Technical Service Bulletin

58D5 UPDATE – Servicing Child Lock (NVLW)

November 7, 2018

Model(s)	Year	VIN Range	Vehicle-Specific Equipment
A5 Sportback	2018	See Campaign/Action screen in Elsa	See Campaign/Action screen in Elsa

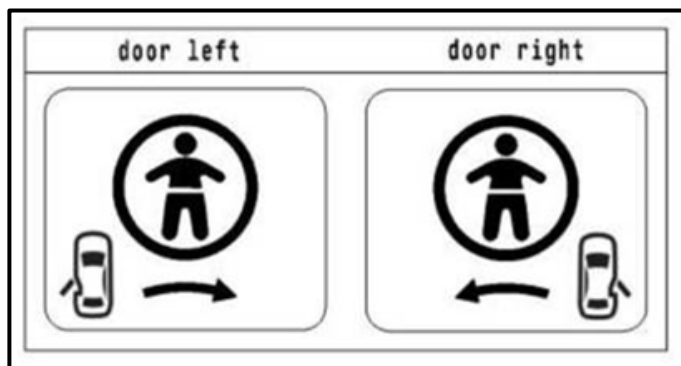
- The embossed symbol for activating the child lock may be reversed. As a result, the child lock cannot be activated in the direction shown by the embossed symbol on the door.

On Audi A5 Sportback vehicles with manual child lock manufactured within a specific period, the embossed symbol for activating the child lock may be reversed. As a result, the child lock cannot be activated in the direction shown by the embossed symbol on the door.

- Open a rear door.
- Turn the child lock in the direction indicated on the symbol on the door.
- Shut the door and try to open the door from the inside.
- If the door will not open using the inside door handle with the child lock turned in the direction indicated on the existing symbol, no further work is required to the door being tested.
- If the door opens using the inside door handle a new label must be installed over the existing child lock symbol.
 - Clean the area as necessary to remove any dirt or debris.
 - Choose the appropriate label based on which door is affected.
 - Ensure minimal air bubbles are created when installing the new label.

Each label part number 8W8.010.530 includes labels for the left and right doors.
